MINERALS PROGRAM INSPECTION REPORT
PHONE: (303) 866-3567

MINE NAME: Ignacio Pit	MINE/PROSPECTING ID#: M-1977-446	MINERAL: Sand and gravel	COUNTY: La Plata
INSPECTION TYPE: Monitoring	INSPECTOR(S): Lucas J. West	INSP. DATE: September 15, 2016	INSP. TIME: 10:00
OPERATOR: Hocker Construction, LLP	OPERATOR REPRESENTATIVE: Roy Hocker	TYPE OF OPERATION: 112c - Construction Regular Operation	
REASON FOR INSPECTION: Normal I&E Program	BOND CALCULATION TYPE: Complete Bond	BOND AMOUNT: \$115,646.00	
DATE OF COMPLAINT: NA	POST INSP. CONTACTS: None	JOINT INSP. AGENCY: None	
WEATHER: Clear	INSPECTOR'S SIGNATURE: 	SIGNATURE DATE: September 28, 2016

Photo Four: View north, showing the reclaimed area on the west side of the pit. The area is gently sloped, well vegetated and evidence of weed treatment is noted.

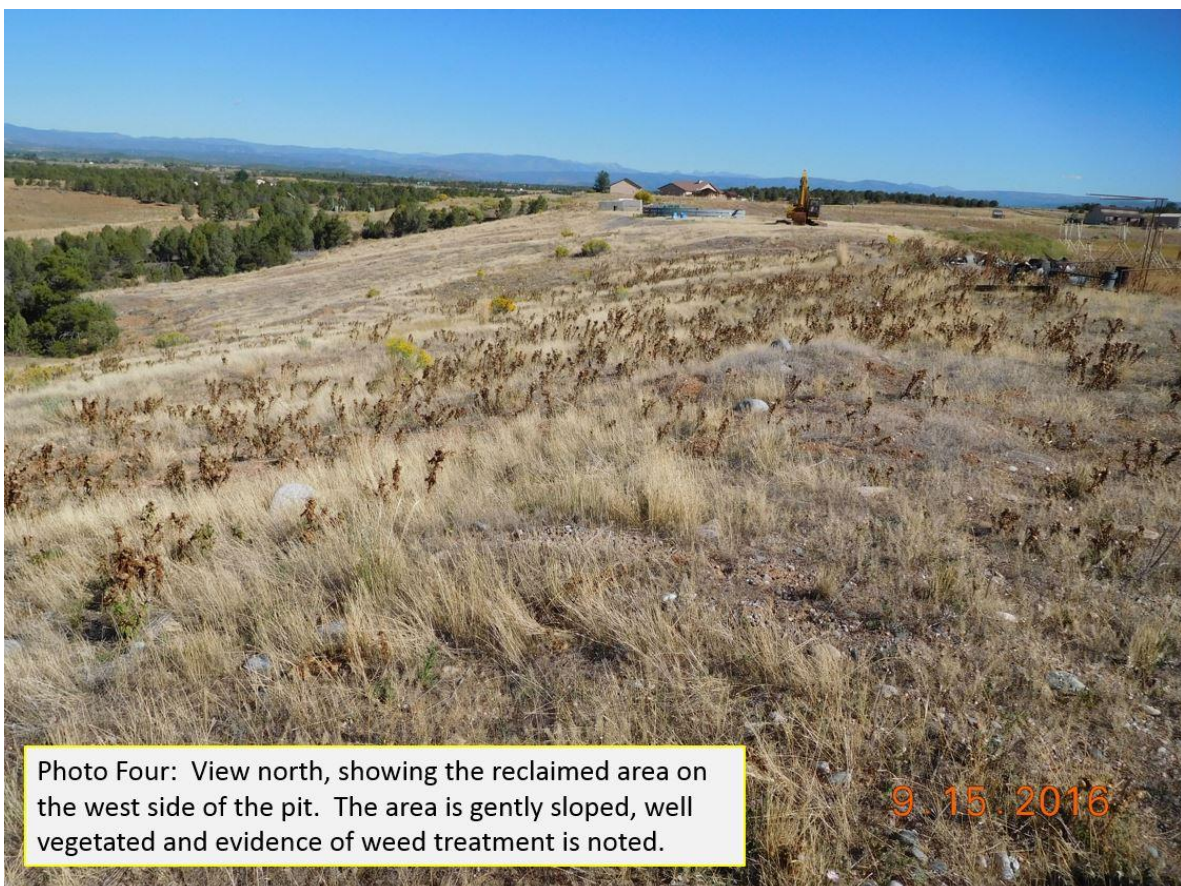
A large area on the west side of the site, approximately 10 acres, has undergone reclamation. The grading of the area appears to be stable and no erosional features were noted. The area has also been vegetated, which is adequate in both density and diversity. The vegetation also shows signs of self-propagation with multiple years growth observed. Photos Four and Five show the reclaimed area. Evidence of chemical treatment of noxious weeds was observed, and conversations with the operator indicate that the weed management plan is active and on-going.
